UNITED STATES
NUCLEAR REGULATORY COMMISSION
ADVISORY COMMITTEE ON REACTOR SAFEGUARDS
WASHINGTON, D. C. 20555

MEMORANDUM FOR: C. Wylie, Chairman, CE System 80 Subcommittee
ACRS Members

SUBJECT: Attached Morning Report on Palo Verde Incident

ANPP/NRC MEETING TO DISCUSS
PVNGS AUXILIARY SPRAY CAPABILITY AND
THE STARTUP TESTING EVENT OF SEPTEMBER 12, 1985

AUXILIARY SPRAY SYSTEM

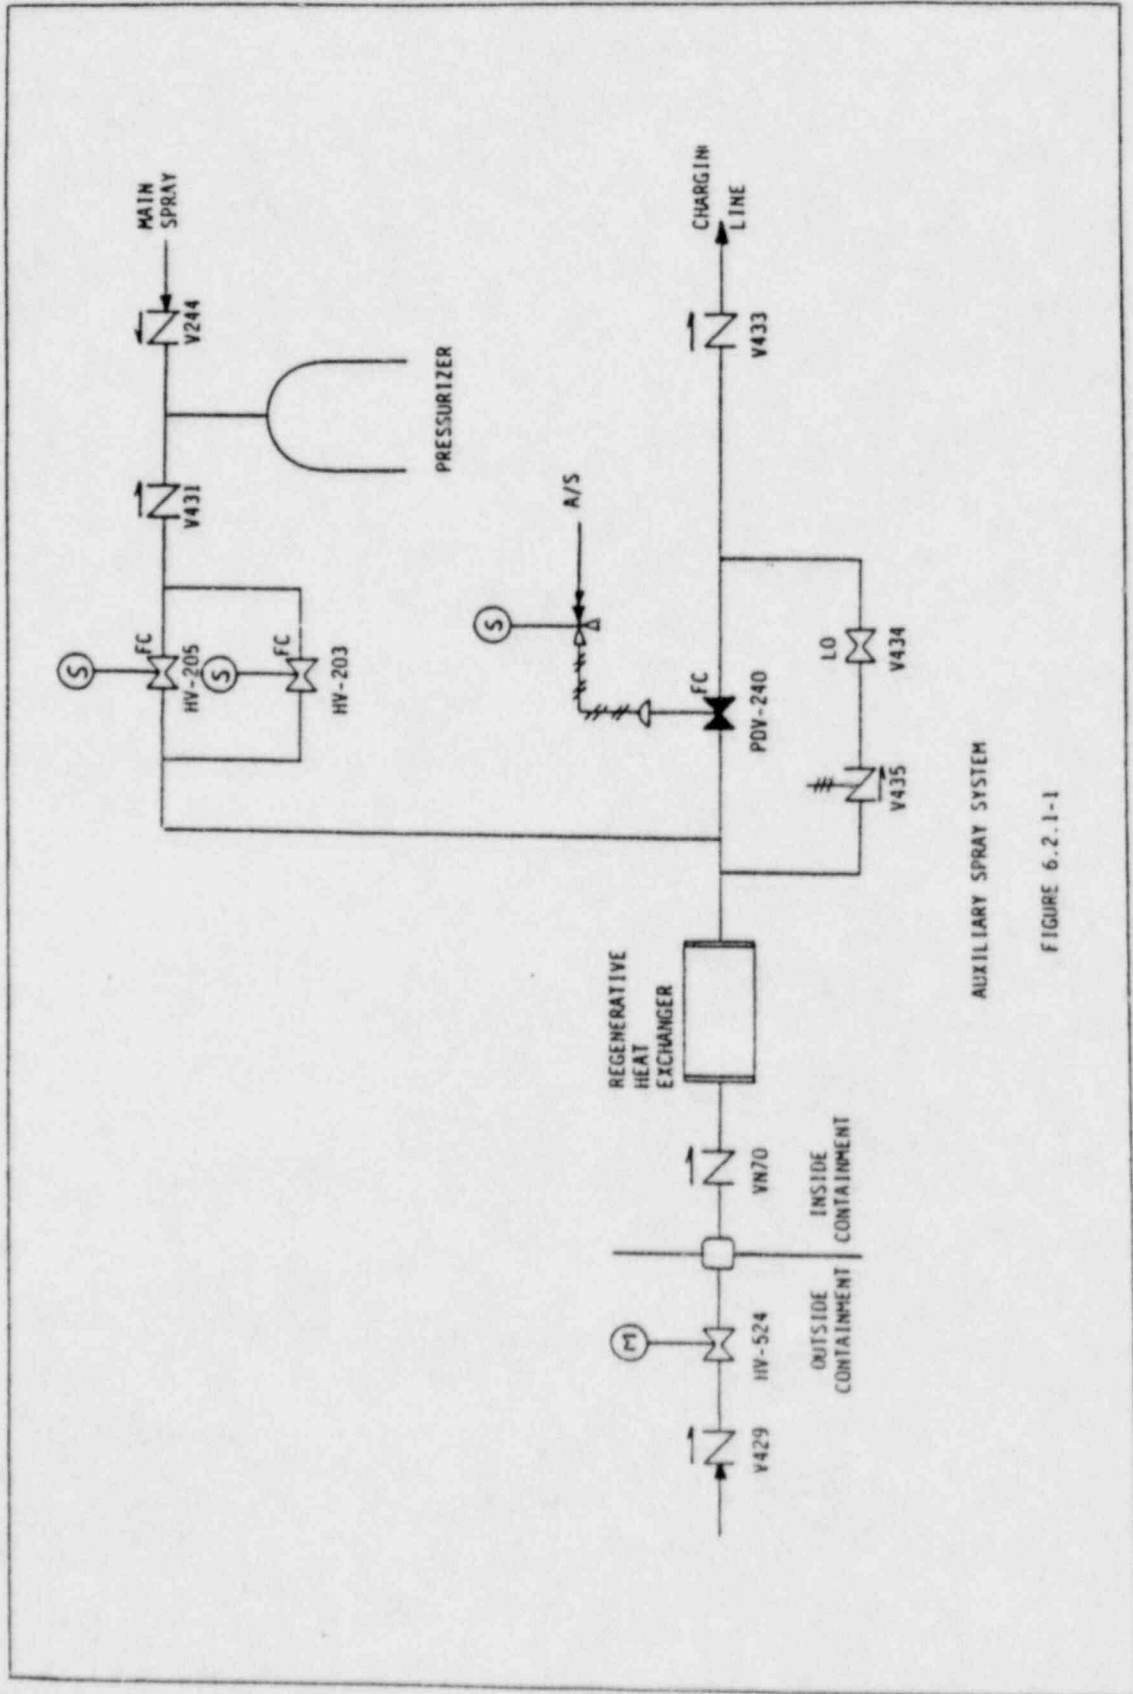
*why was some of water
not identified*
